**Economic and Social Council**Distr.: General
8 February 2018

Economic Commission for Europe**Inland Transport Committee****World Forum for Harmonization of Vehicle Regulations****Working Party on Lighting and Light-Signalling****Seventy-ninth session**

Regulations Nos. 37 (Filament lamps), 99 (Gas discharge light sources), 128 (Light emitting diodes light sources) and the Consolidated Resolution on the common specification of light source categories**Proposal to amend the approval code for light sources****Submitted by the expert from the International Electrotechnical Commission (IEC) ***

Annex 2, amend to read:

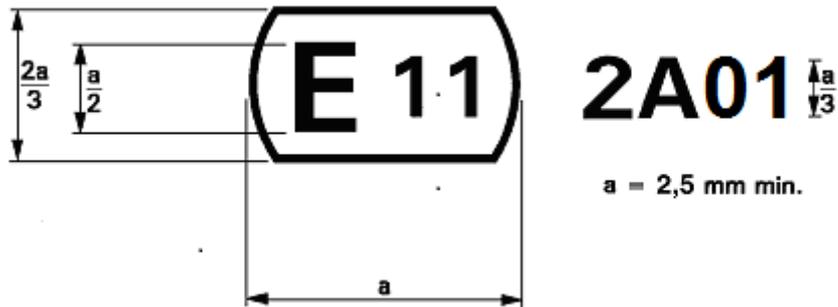
"Approval No. Extension No.

Approval Code

1. Trade name or mark of the ~~device~~ **filament light source**:.....
2. Manufacturer's name for the type of ~~device~~ **filament light source**:
3. Manufacturer's name and address:

Annex 3, the graph,

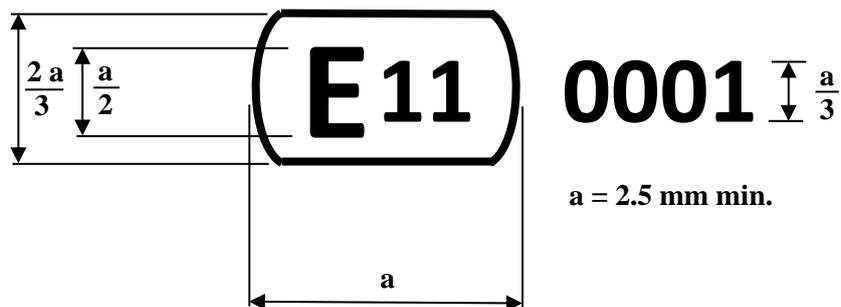
replace by a new graph, to read (replacing the example of the approval code and correcting the decimal coma):

“ The above approval mark affixed to a filament light source indicates that the light source has been approved in the United Kingdom (E 11) under the approval code ~~A01-0001~~.

Annex 2, amend to read:

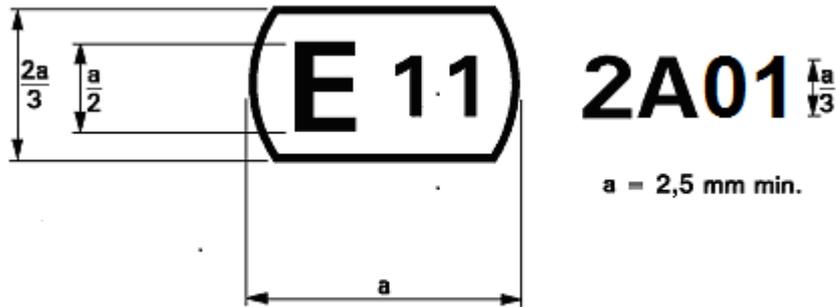
" Approval No:..... Extension No:.....

Approval Code:.....

Annex 3, the graph,

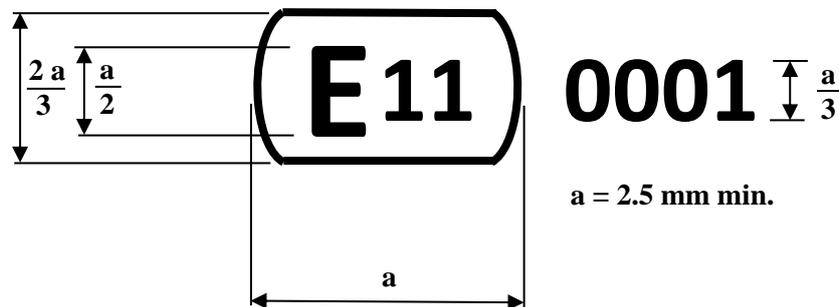
replace by a new graph, to read (replacing the example of the approval code and correcting the decimal coma):

“ The above approval mark affixed to a gas-discharge light source indicates that the light source has been approved in the United Kingdom (E 11) under the approval code ~~0A01~~ **0001**. The first character of the approval code indicates that the approval was granted in accordance with the requirements of Regulation No. 99 in its original form.”

Annex 2, amend to read:

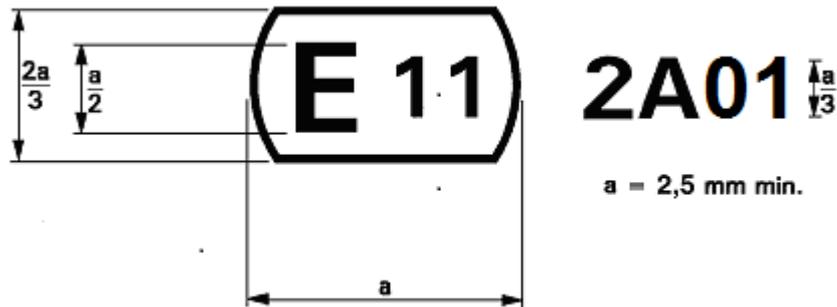
"Approval No.....

Extension No.....

Approval Code.....

1. Trade name or mark of the device LED light source:
2. Manufacturer's name for the type of device LED light source:
3. Manufacturer's name and address:

Annex 3, the graph,

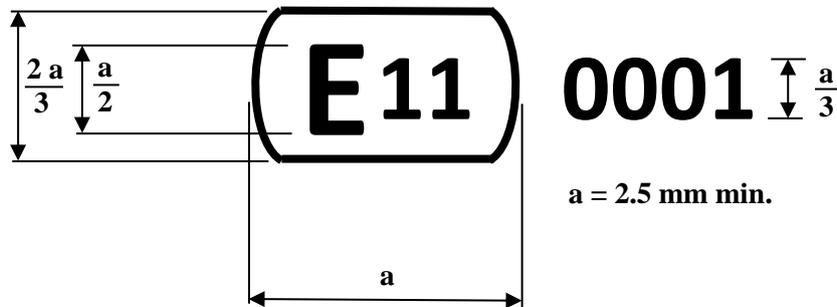
replace by a new graph, to read (replacing the example of the approval code and correcting the decimal coma):

“ The above approval mark affixed to a LED light source indicates that the light source has been approved in the United Kingdom (E11) under the approval code ~~0A01~~ **0001**. The first character of the approval code indicates that the approval was granted in accordance with the requirements of Regulation No. 128* in its original form.
